## Memorandum

Job N°: 14989.002

**Subject: Mundamia Residential Subdivision Traffic Review**

**Figure 1: Proposed Jemalong Residential Subdivision**

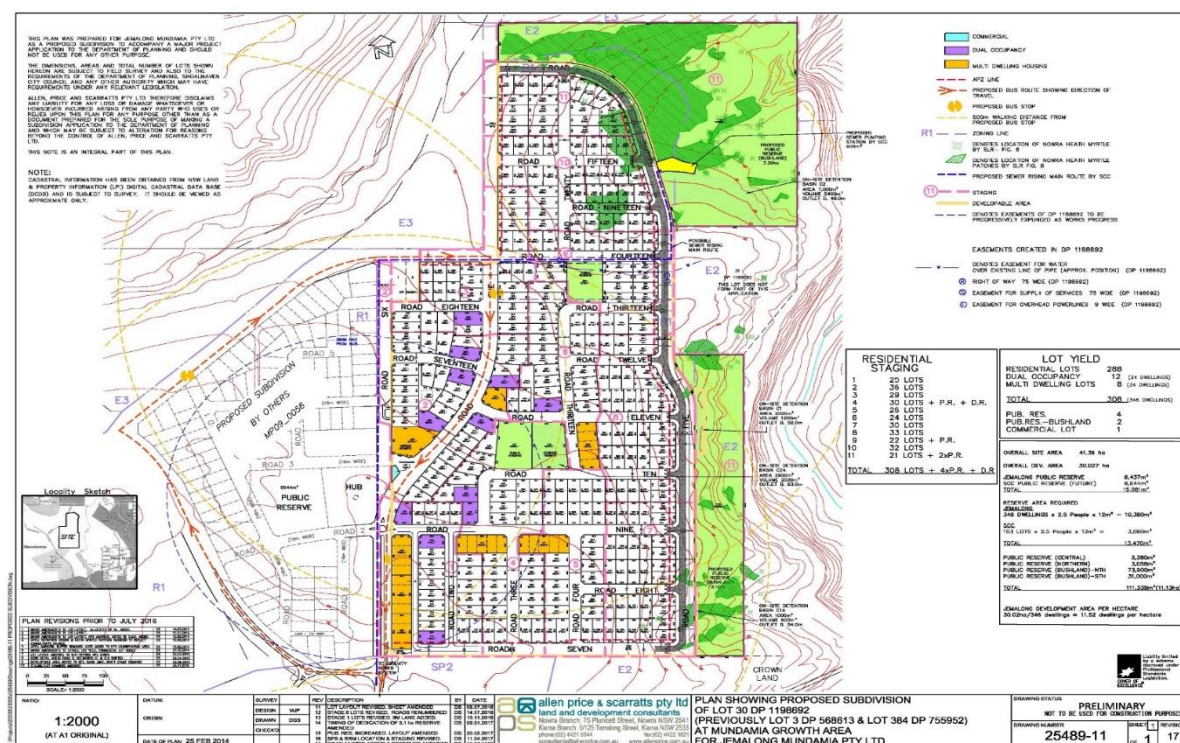
Road One between George Evans Road and Road Sixteen, illustrated in **Figure 1**, will function as a collector road and will have the following characteristics:

- The section between George Evans Road and Road Nine will be a boulevard with a divided carriageway with one lane in each direction and parking permitted on both sides. It is understood that no vehicular access to and from the adjacent land use will be permitted on that section of road. If parking is permitted adjacent to residences, then the roundabout at the junction of Road Nine with Road One would facilitate access to the eastern side of the roadway.
- The section between Road Nine and Road Sixteen will have a two-lane undivided carriageway with parking permitted on both sides; residences along the road will have direct access to it.
